ATTACHMENT 1

RPI24/007: SANTOS – LEGHORN DEV C RESPONSE TO REQUIREMENT NOTICE

Table 1 - DSDIP Information Requirement and Santos' Response

Appendix A – Well Evaluation Summary (Leghorn 1)

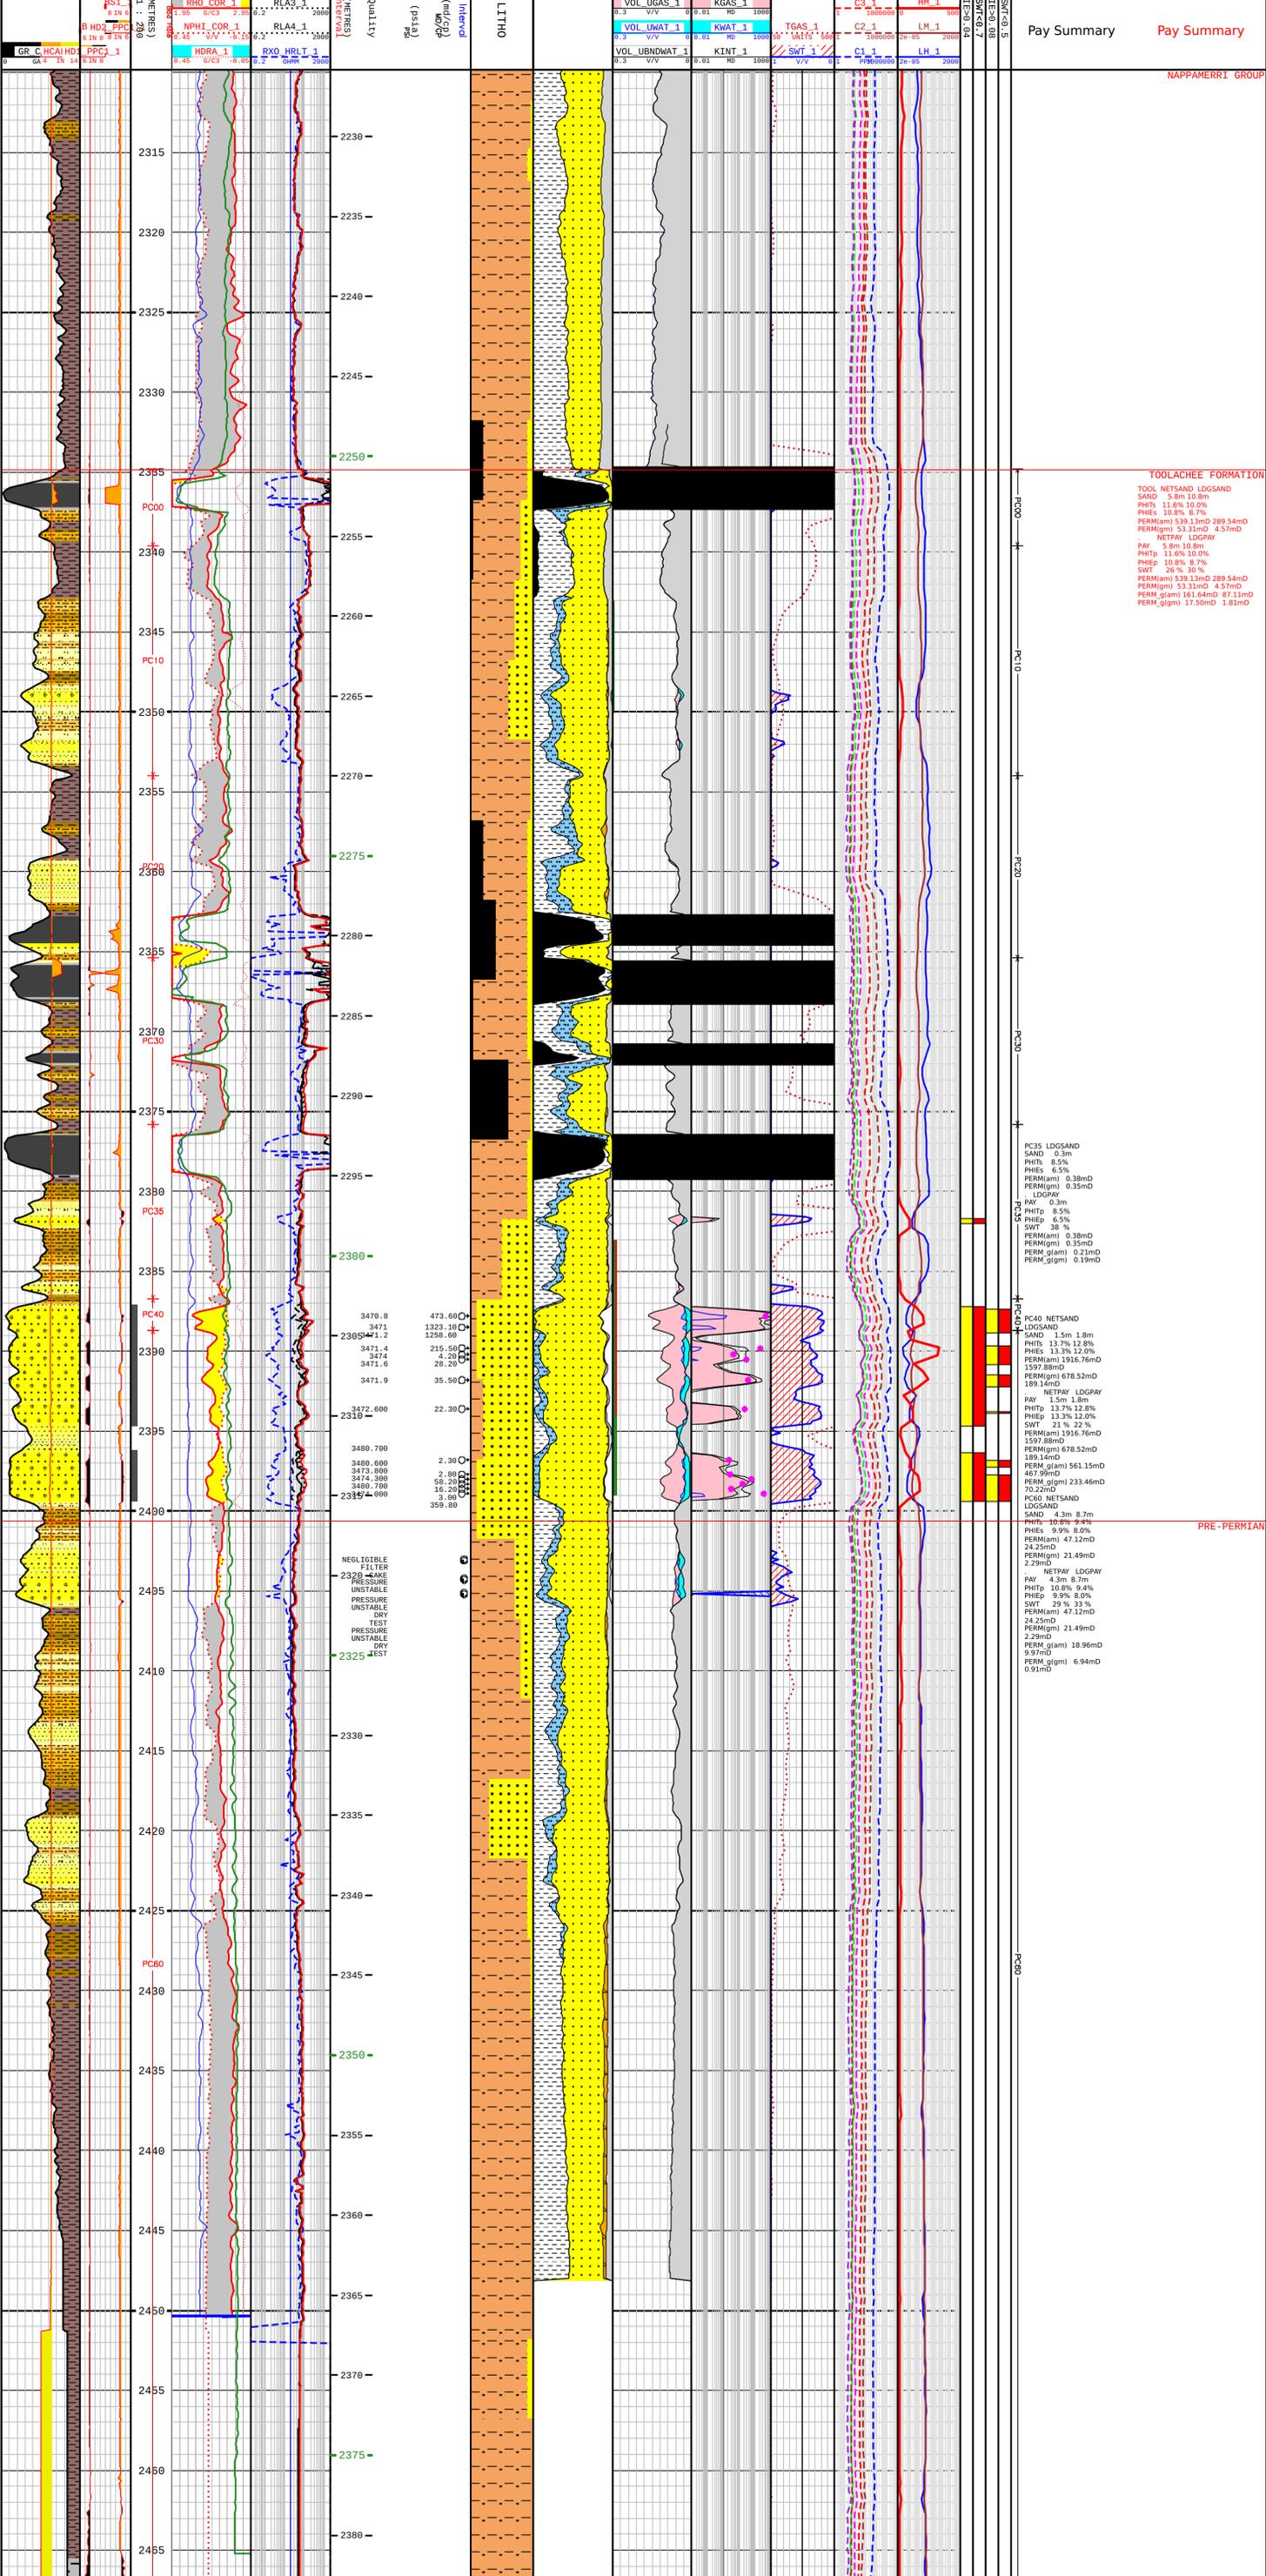
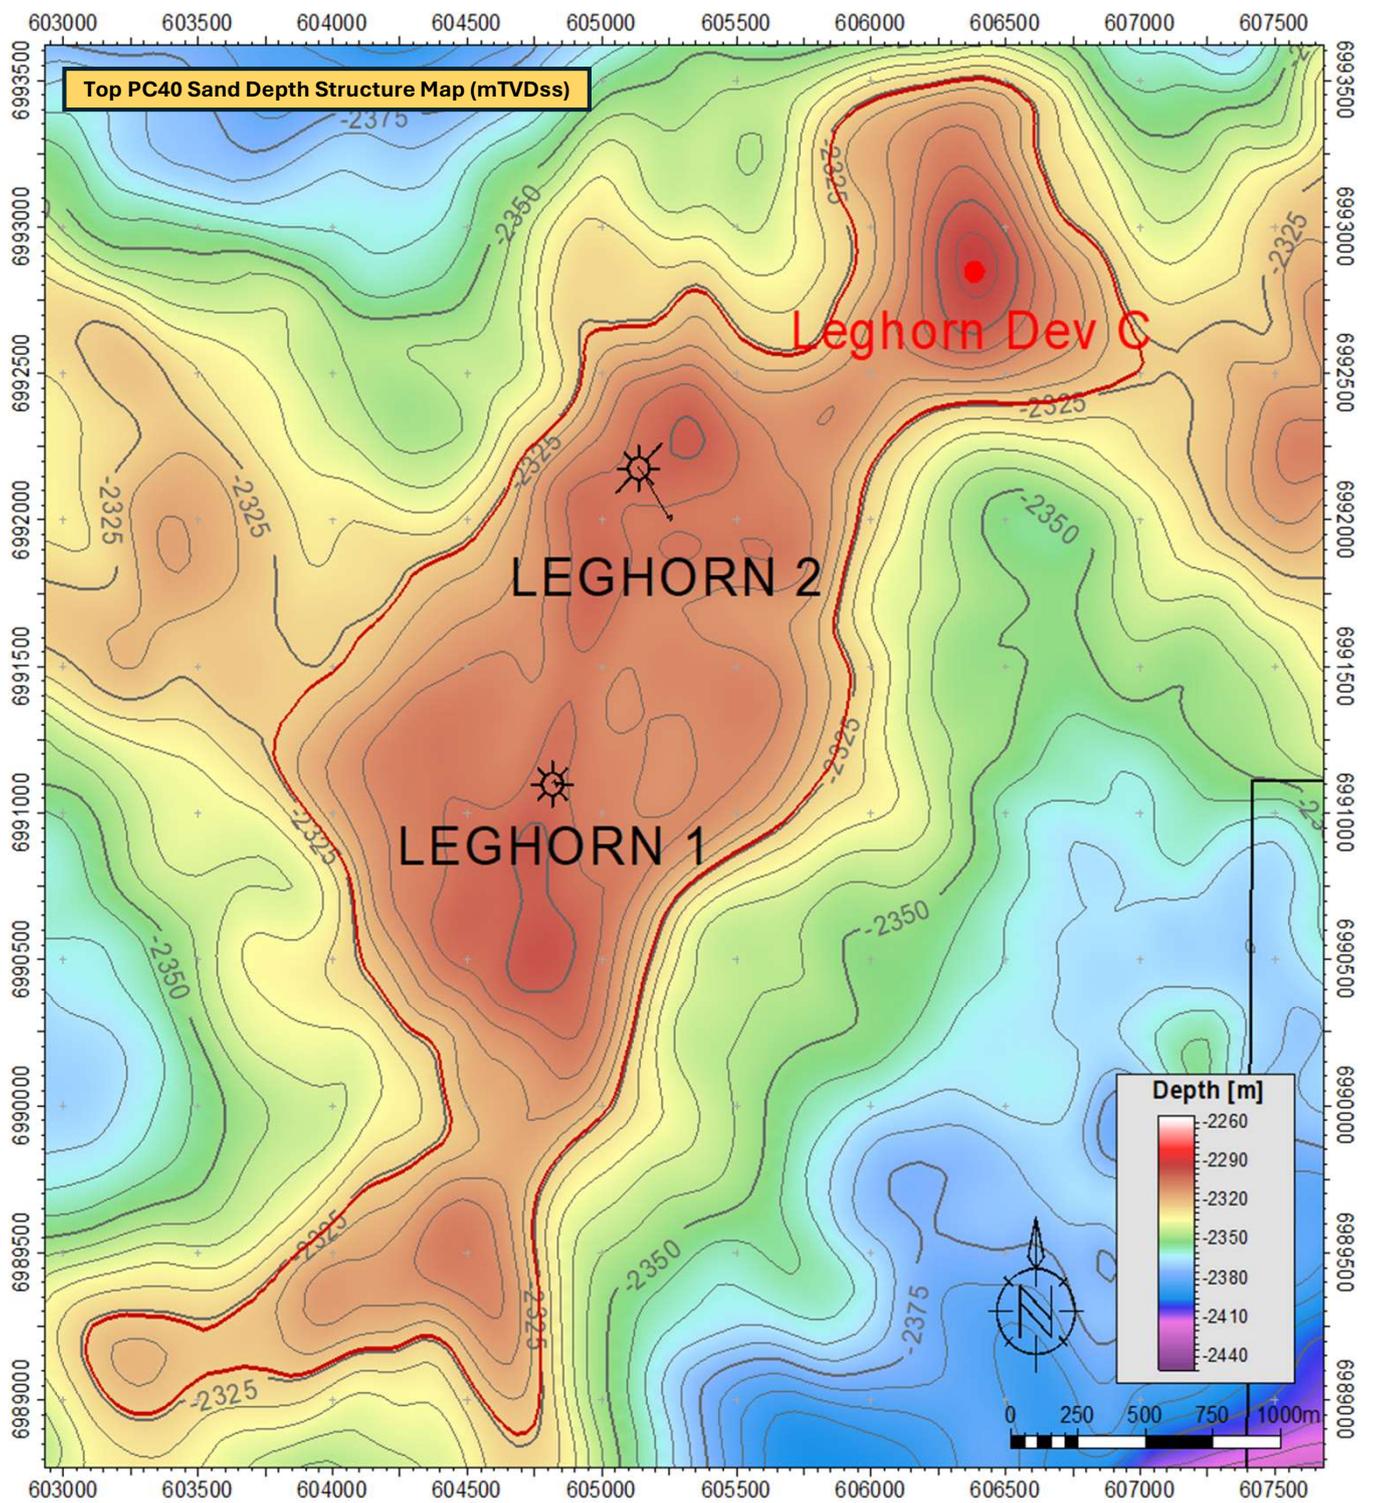
<p>Action:</p> <p>Provide a detailed explanation of how the proposed gas well meets the definition of conventional gas or oil (as outlined in Schedule 2, Part 5, Item 3 of the RPI Regulation) by providing information about the type of underground reservoir, its characteristics (e.g., porosity, permeability, and geological structure), and confirmation of the extraction method (i.e., no fracking will be required). Additionally, include any relevant geological data or studies that support the classification of the well as conventional.</p>	<p>RPI REGULATION</p> <p>The scope of work within Leghorn Area clearly meets the criteria of Schedule 2, Part 5, Item 3(a)(i) as the gas is contained within a natural underground reservoir largely consisting of porous sandstone, capped by impermeable rock and trapped in discrete accumulations by buoyancy, allowing for its recovery to ground level from a petroleum well. In accordance with Schedule 2, Part 5, Item 3(a)(i) and Item 3(b) of the RPI Regulation, Leghorn is defined as 'conventional gas or oil' as (emphasis added in bold):</p> <p style="padding-left: 40px;"><i>conventional gas or oil—</i></p> <p style="padding-left: 40px;"><i>(a) means a gas or oil contained in, or extracted from—</i></p> <p style="padding-left: 40px;"><i>(i) a natural underground reservoir largely consisting of porous sandstone capped by impermeable rock in which the gas or oil is trapped in discrete accumulations by buoyancy allowing release or recovery of the gas or oil to ground level from a petroleum well and, for a gas, often without the need for pumping; or</i></p> <p style="padding-left: 40px;">...</p> <p style="padding-left: 40px;"><i>(b) does not include unconventional gas or oil.</i></p> <p>As mentioned in Santos’ response to Issue 1, in the absence of explicit use of "and" or "or" in the definition of 'unconventional gas or oil', all three criteria under Schedule 2, Part 5, Item 3(b) (i), and (ii), and (iii) of the RPI Regulation must be met for oil or gas to be classified as "unconventional."</p>

<p>DSDIP Information Request <i>Information required for assessment against SEA criteria – Schedule 2, Part 5 of the Regional Planning Interests Regulation 2014 (RPI Regulation)</i></p>	<p>Santos Response</p>
	<p>Furthermore, the definition of conventional gas or oil as per Item 3(a)(ii)(B) in the RPI Regulations states hydraulic fracturing may be required for the release or recovery of the gas or oil to ground level when the geological formation largely consists of sandstone capped by impermeable rock and has reduced porosity and permeability:</p> <p><i>conventional gas or oil—</i></p> <p>...</p> <p><i>(B) has reduced porosity and permeability and may require hydraulic fracturing in certain circumstances to allow the release or recovery of the gas or oil to ground level;.</i></p> <p>The RPI Regulation explicitly contemplates the recovery of conventional gas or oil from geological formations may require hydraulic fracturing in certain conventional gas or oil circumstances. Due to the expected lower porosity nature of the target reservoir based on nearby exploration well results, the application of a single stage of hydraulic fracturing may be required to support gas production as part of the Leghorn Dev C well development. This is consistent with the approach taken for field development nearby.</p> <p>In response Issue 1 and Issue 2, the information provided for the proposed Leghorn Dev C development aligns with the definition of 'conventional gas or oil' as outlined in the RPI Regulation.</p> <p>Given the minor nature of the proposed activities and the mitigation measures described throughout the RPI24/007 Assessment Report and Santos's response to each issue in the Requirement Notice, the proposed activities are unlikely to result in widespread or irreversible impacts within the Channel Country SEA.</p> <p>LEGHORN AREA</p> <p>For the Leghorn Dev C proposed activities, the primary reservoir target is the conventional sandstones within the Toolachee Formation. Santos operations in the Leghorn Area are defined as conventional operations because the gas is reseroired in Permian-aged porous sandstones, trapped in discrete accumulations (anticlinal closures) by buoyancy which aligns to Section 3 of the RPI Regulation's definition of conventional gas or oil. The RPI Regulation also states that where a natural underground reservoir is largely consisting of sandstone capped by impermeable rock and has reduced porosity and permeability, hydraulic fracturing in certain circumstances can be required for conventional gas operations.</p> <p>Santos is exploring for and developing conventional gas in the Leghorn area (where the RPI24/007 application's scope of works is proposed to occur) (Leghorn Area). Results from testing sites within the Leghorn Area (specifically the millidarcies and porosity of nearby Leghorn 1 and Leghorn 2 drills).</p>

<p>DSDIP Information Request <i>Information required for assessment against SEA criteria – Schedule 2, Part 5 of the Regional Planning Interests Regulation 2014 (RPI Regulation)</i></p>	<p>Santos Response</p>
	<p>As mentioned above, the Santos operations in the Leghorn Area are defined as conventional operations because the gas is reservoired in Permian-aged porous sandstones, trapped in discrete accumulations (anticlinal closures) by buoyancy. Primary reservoir target is the conventional sandstones within the Toolachee Formation</p> <p>Permeabilities within the Leghorn Area are expected in the range of 1 to 1000s of millidarcies, with maximum mobility of 1323md/cP measured at Leghorn 1. Average porosity within the Toolachee Formation reservoir in Leghorn 1 was 13.3%, with an average permeability of 539 millidarcy (Appendix A demonstrates the well evaluation summary for the nearby Leghorn 1 drill). Leghorn 2 appraisal drill encountered poorer reservoir quality with an average porosity of 7.8% during its exploration scope, permeability of 1 millidarcy and measured mobilities up to 1.89md/cP. Fracture stimulation was required for sufficient hydrocarbon flow in Leghorn 2 and one fracture stimulation stage was executed.</p> <p>In addition to Appendix A (the Leghorn 1 Well Summary), Appendix B presents the Leghorn 1 and Leghorn 2 cross section, while Appendix C provides a Leghorn / Toolachee Formation Depth Map.</p>
